# Access Compliance Report

## Public Rights-of-Way

### (Curb Ramps)

Intersection ID: 10034400	Main Street: PIEDMONT_PARK_DR	Cross Street: AUDUBON_PARK_DR	Location:	N
ADA ID: 187FDF3A75ED	Ramp Type: Directional1	Initial Pass/Fail: Fail	Overall Compliance: No	Severity Score: 1.25

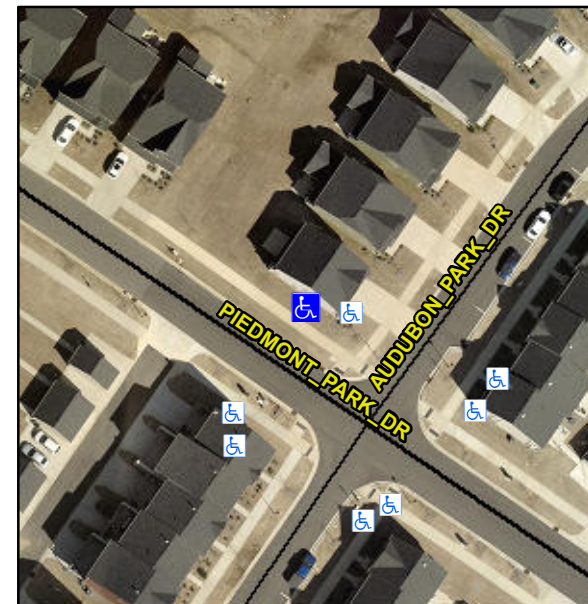
Possible Solutions:

**Remove & Replace Entire Ramp.**

PROW/ADA:

**R304.5.3**
